# Water Right Conditions Tracking Slip

**PUBLIC INTEREST REVIEW FOR GROUNDWATER APPLICATIONS**

SUBJECT: Application G- 17434 Supersedes review of \_\_\_\_\_ Date of Review(s) \_\_\_\_\_

# Groundwater Application G-17434, Kregger Farming Umatilla County, Smeltz & Touchet Quads

### Location of Gravel Wells, UMAT 4691 & UMAT 50354 Umatilla County, Milton-Freewater Quad

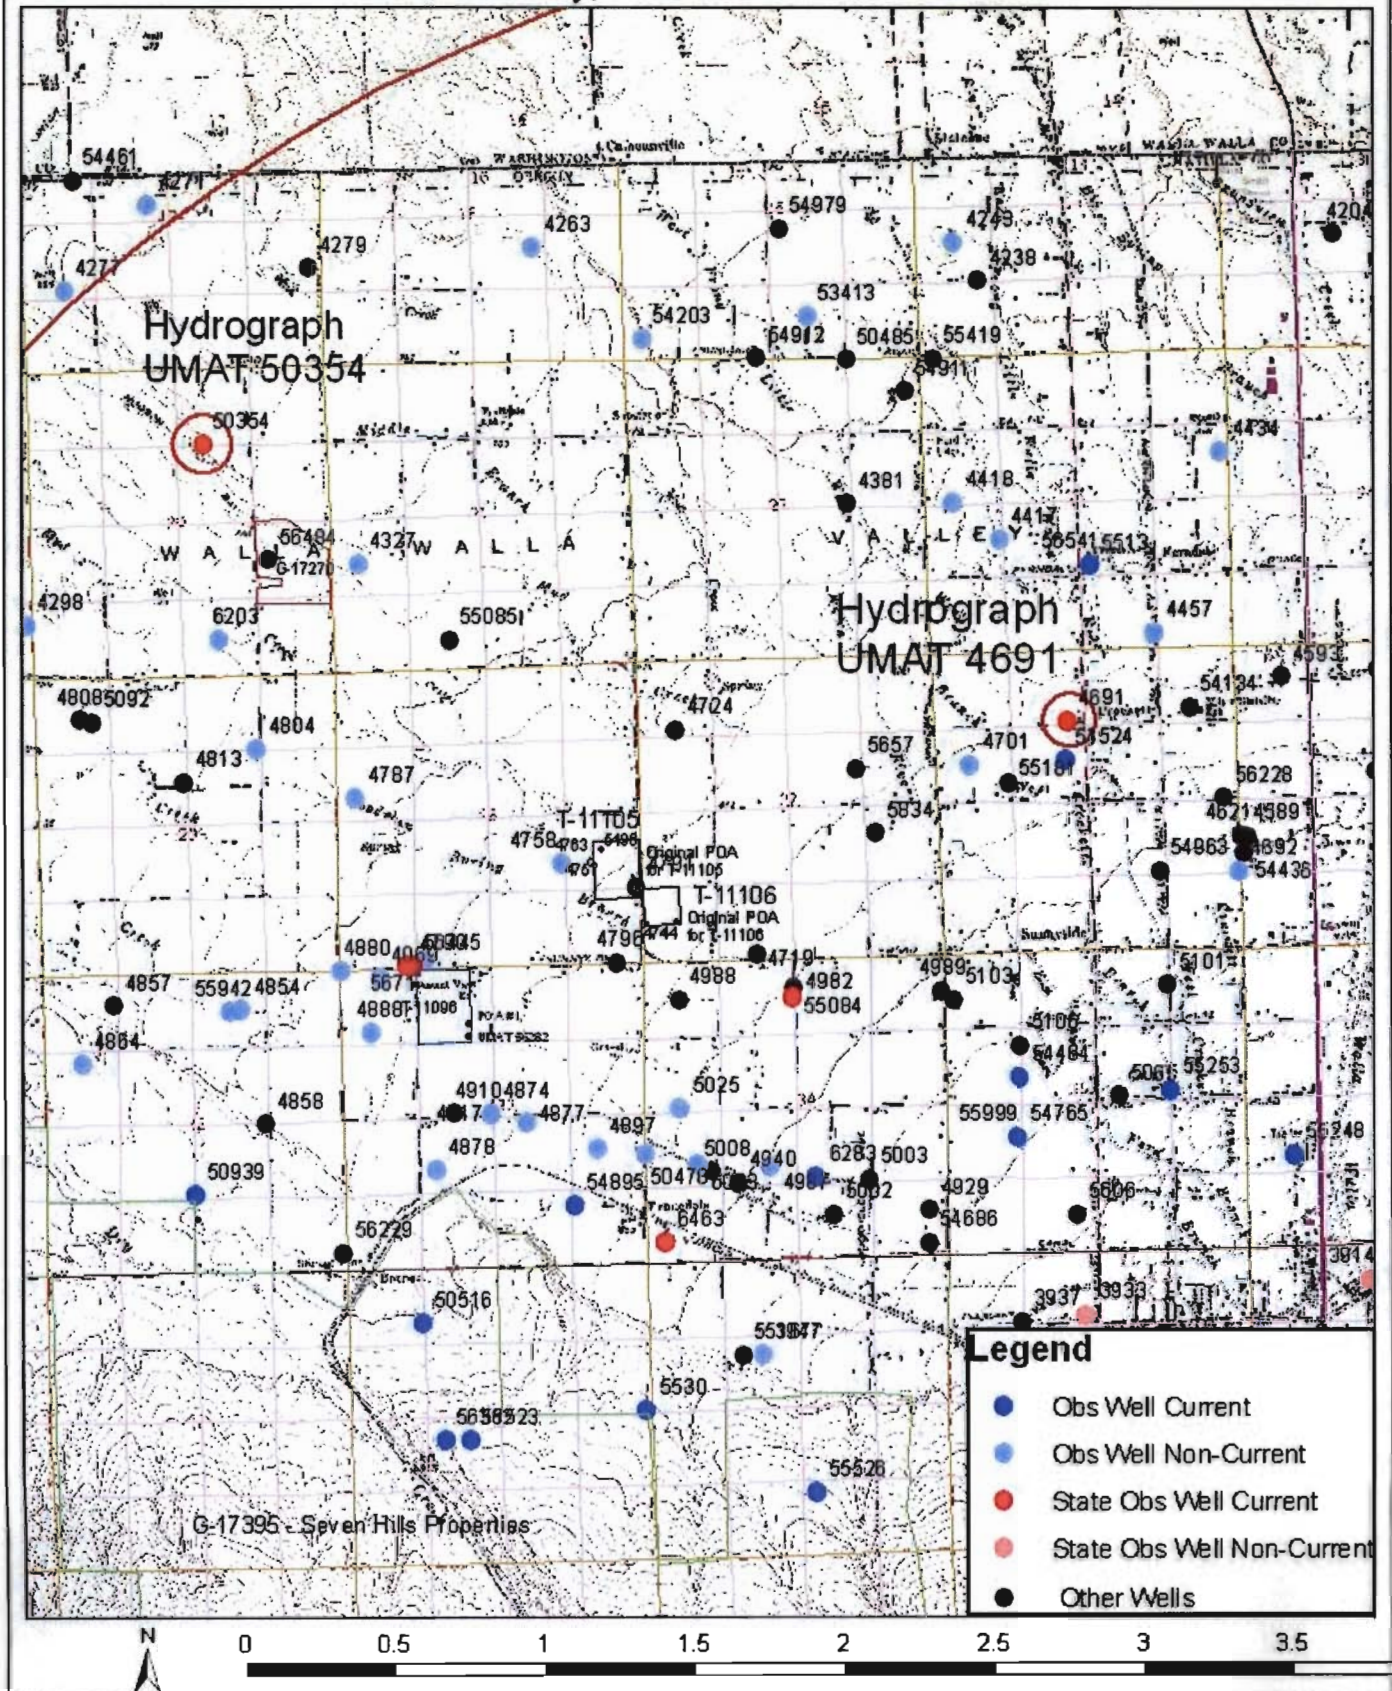
Declines in the alluvial aquifer increase towards Milton-Freewater. A map on page 9 shows the location of long-term ground water monitoring wells UMAT 4691 and UMAT 50354. Hydrographs for the wells are on page 10. The groundwater levels at these wells document a 12 to 15 foot decline over the last 60 years.
